Boatmans, 42 City Road East,
Manchester.

External Wall Review

Project name	External Wall Review, Boatmans, Manchester
Design note title	External Wall Review
Site Address	Boatmans, 42 City Road East, Manchester M15 4QF
Client name	Boatmans Management Company Ltd
Document reference	1476257586
Revision	0.1 Draft
Date	19 November 2021

Figure 5 - External wall capped as parapet and Wall Type 4

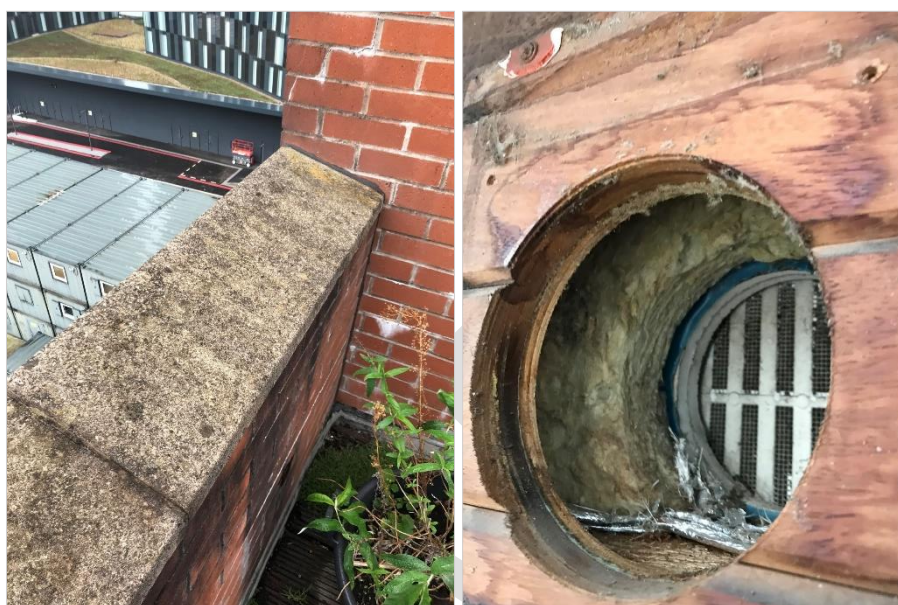
- It was confirmed the clay tiles are bonded directly to dense concrete blockwork and the clay tiles are only used around the car park ground floor level.

- The concrete blockwork on the uppermost storey wall is taken up to the underside of the roof.
- Cavities are closed at the head of the wall via coping stone where the external wall becomes a parapet wall (see Figure 5 below).

- All the timber cladding inspected to the top floor apartments (no's 28 & 26) was fitted to the blockwork via timber studs but with no combustible insulation (or insulation at all) to the void between the cladding and concrete blockwork.

- The soffit board material appeared to be HPL 6mm thick (this has not been confirmed).
- Regarding flats with balconies along River Place (Apartment no's 10 & 14), these apartments only have timber cladding above the balcony doors (accessible from the balcony). The wall construction (see Figure 5 below) is as follows:

- 2x12.5mm plasterboard
 - VCL (appeared to be a DPM type material)
 - 50mm mineral wool
 - 50mm Void
 - 11mm plywood
 - 18mm cedar timber cladding

This wall build-up was not considered by the Ark Façade Survey. This will now be Cladding / Wall Type 4 - timber cladding to balconies.

Wall Type 3 - The substrate behind the clay tiles has been investigated in as part of the additional works carried out by Quality Fast Facades Ltd. It was found the clay tiles are bonded directly to dense concrete blockwork. This wall type meets the guidance of ADB 2019.

Wall Type 4 - The requested information for timber around the balconies found timber cladding above the balcony doors (accessible from the balcony). It is recommended the extent of this wall type is further investigated. It is understood the Building Safety Fund (BSF) has confirmed remediation is required for the timber cladding, following previous advice (email forwarded by Chris Frankish Mon 18/10/2021 13:46). This wall type does not meet the guidance of ADB 2019.

Figure 7: Diagram 5.3 of ADB 2019

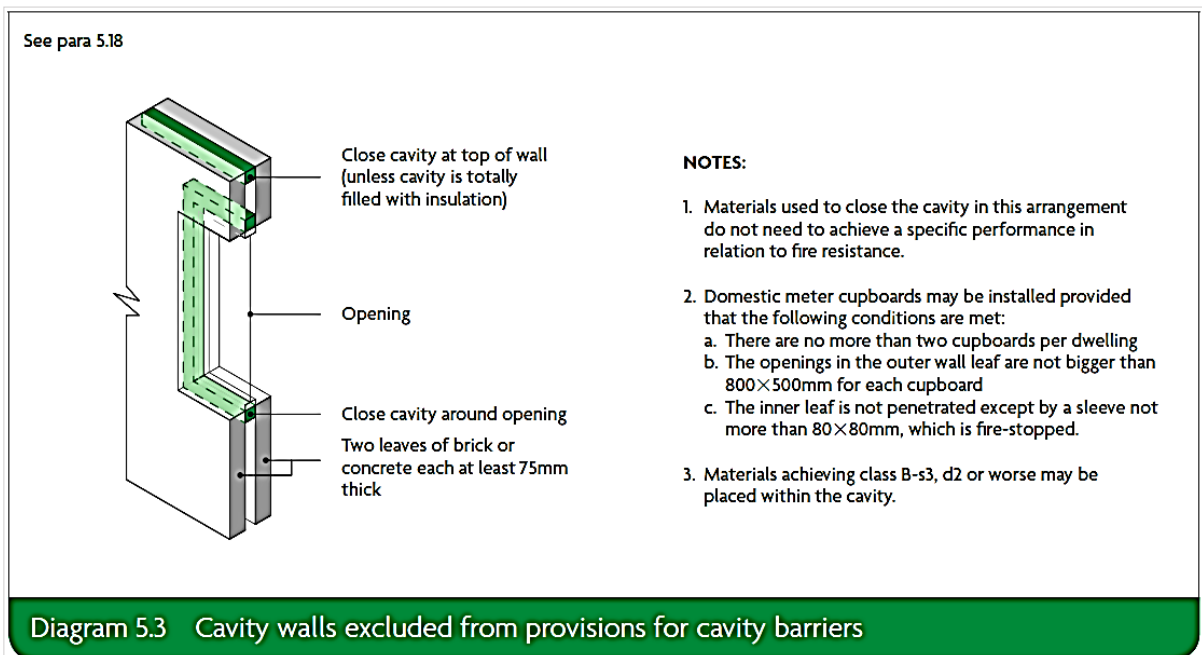
The Arc Façade Survey does not investigate the masonry wall to its full thickness. However further investigation by Quality Fast Facades Ltd has shown that the Wall Type 1 meets with Diagram 5.3.

With two leaves of brick or concrete each at least 75mm thick, Wall type 1 only requires cavity barriers around openings. The cavity is currently not fully filled with insulation so must also be completely closed at the top of the wall.

Wall Type 1 - This wall type meets the guidance of ADB 2019.
